UNITED STATES PATENT AND TRADEMARK OFFICE

APPLICATION NO.	FILING DATE	FIRST NAMED INVENTOR	ATTORNEY DOCKET NO.	CONFIRMATION NO.
10/815,785	04/02/2004	Nicola Leone	T8-467921US	9935

Office Action Summary

DETAILED ACTION

Krauser, 7,774

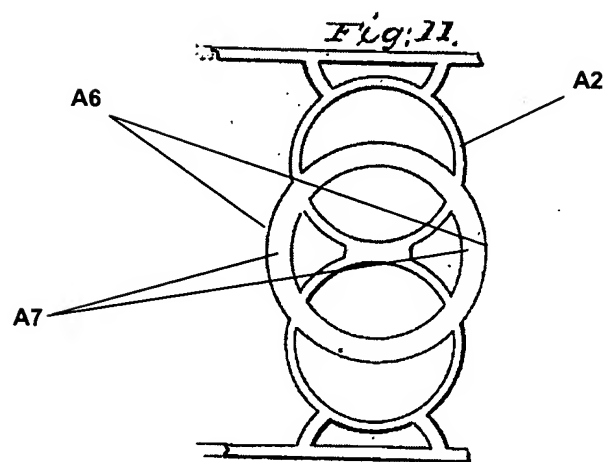
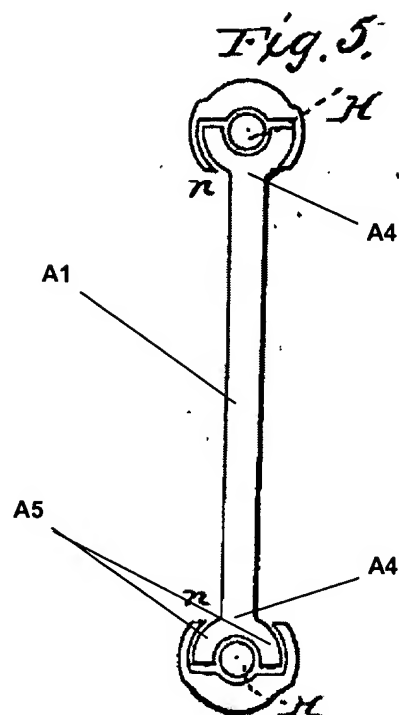
Regarding claim 1, Krauser discloses, in Figure 1, an ornamental insert comprising a body **A1** having a perimeter **A2**, and brackets **n** projecting from the perimeter **A2** from diametrically opposite sides **A4** of the body **A1**. Each of the brackets **n** has a pair of opposed sidewalls **A5**.

Regarding claim 2, the body **A1** has abutment surfaces **A6** formed on the perimeter **A2** on diametrically opposite sides **A7** of the body **A1** between the brackets **n** and equi-spaced from the brackets **n**.

Regarding claim 3, the body **A1** is selected from the group consisting of circular, astroidal, diamond-shaped, cross-shaped, and elliptical-shaped inserts.

Regarding claim 4, Krauser discloses, in Figure 1, an ornamental insert comprising a body **A1** having a perimeter **A2**, and brackets **n** projecting from the perimeter **A2** from diametrically opposite sides **A4** of the body **A1**. Each of the brackets **n** has a pair of opposed sidewalls **A5**. The body **A1** has abutment surfaces **A6** formed on the perimeter **A2** on diametrically opposite sides **A7** of the body **A1** between the brackets **n** and equi-spaced from the brackets **n**. However, Krauser discloses the abutment surfaces **A6** being rightward and leftward and the brackets **n** projecting vertically from the perimeter. Applicants should note that the limitations “upwardly” and “downwardly” are relative terms that orienting the insert 90 degrees from vertical will place the abutment surface upward and downward and the bracket will project horizontally from the perimeter.

Hainsworth, 386,124

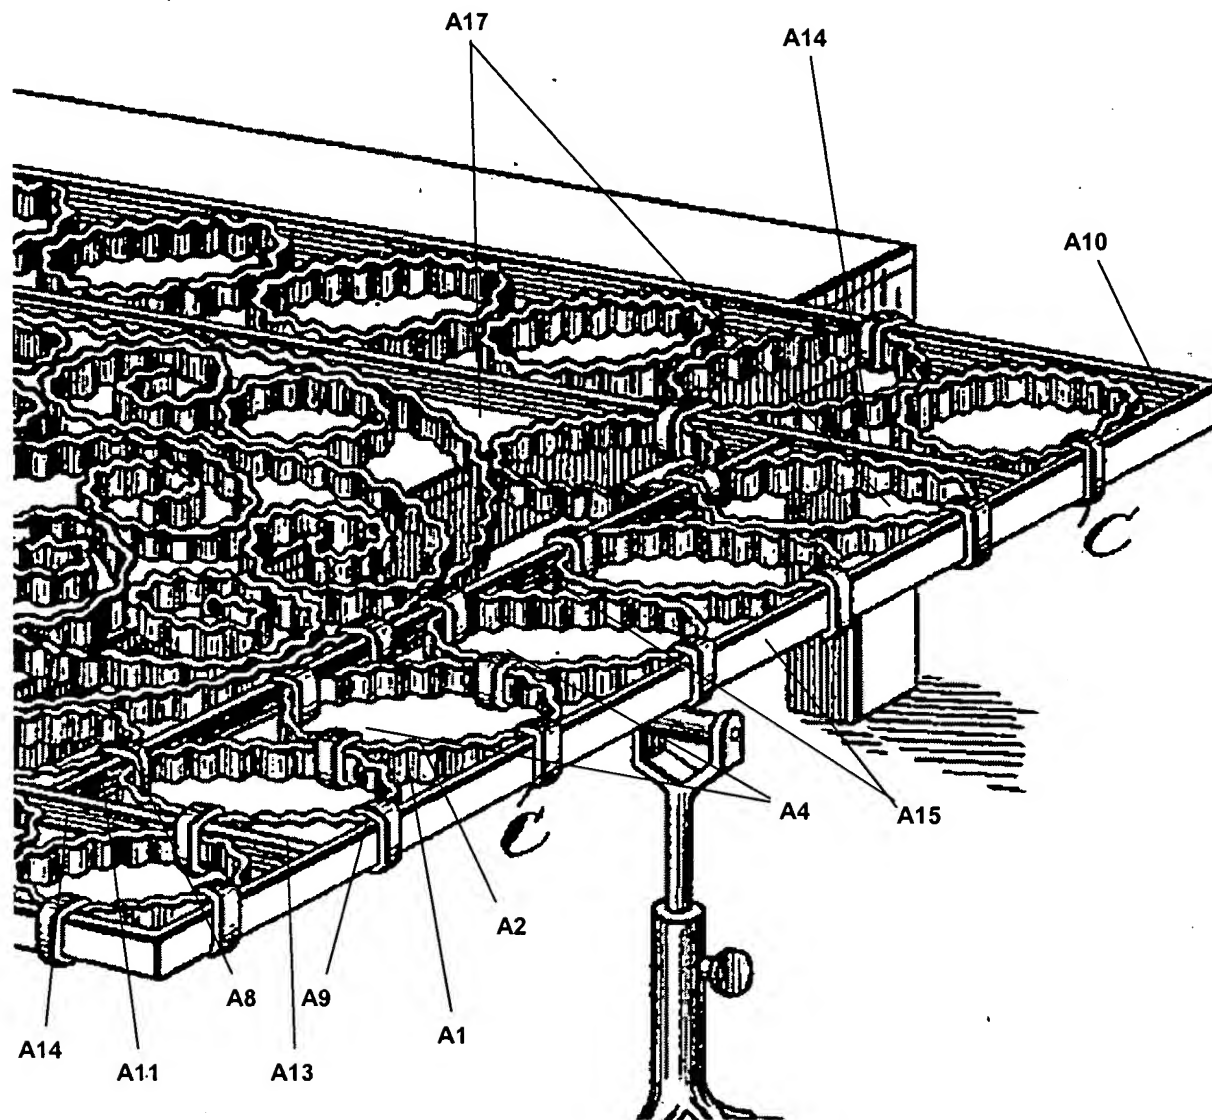
Regarding claim 4, Hainsworth discloses, in Figure 3, an ornamental fence insert comprising a body **A1** having a perimeter **A2** and brackets **C**. An upwardly facing abutment surface **A8** and a downwardly facing abutment surface **A9** are formed on the perimeter **A2**. The brackets **C** project outwardly and horizontally from the perimeter **A2** of diametrically opposite sides **A4** of the body **A1**. Each of the brackets **C** has a pair of opposed sidewalls **A5** defining a u-shape.

Regarding claim 5, the upwardly facing abutment surface **A8** is seated on a rail top surface **A10** and the downwardly facing abutment surface **A9** is in abutment with a top rail bottom surface **A11**.

Regarding claim 6, the sidewalls **A5** are joined by a web **A12**.

Regarding claim 7, each of the sidewalls **A5** overlaps a surface **A13** of one picket **A14** in a direction of a horizontally extending direction of rails **A15**.

Regarding claim 26, Hainsworth discloses, in Figs. 1, 3, and 4, a trellis comprising a pair of parallel, spaced-apart rails **A14**, transverse equispaced pickets **A15**, and an ornamental insert (Fig. 3). The pickets **A15** extend between the rails **A14** and are joined to the rails **A14** defining rectangular openings **A17** with the rails **A14**. The insert comprises body **A1** having a perimeter **A2**, and brackets **C** project from the perimeter **A2** from diametrically opposite sides **A4** of the body **A1**. Each of the brackets **C** has a pair of opposed sidewalls **A5**.

Regarding claim 27, the openings **A17** are square (some are square and rectangular) and the insert is circular and has abutment surfaces (abutment surfaces are around the perimeter) formed on the perimeter **A2** on diametrically opposite sides of the body **A1** between the brackets **C** and equispaced from the brackets **C** about the perimeter **A2**.

Hainsworth teaches, in Figs. 1, 3, and 6, an ornamental insert to make an ornament fence. The insert comprises a body **A1** having a perimeter **A2** and brackets **C**. An upwardly facing flat abutment surface **A8** and a downwardly facing flat abutment surface **A9** are formed on the perimeter **A2**. The brackets **C** project outwardly and horizontally from the perimeter **A2** of diametrically opposite sides **A4** of the body **A1**. Each of the brackets **C** has a pair of opposed sidewalls **A5** defining a u-shape.
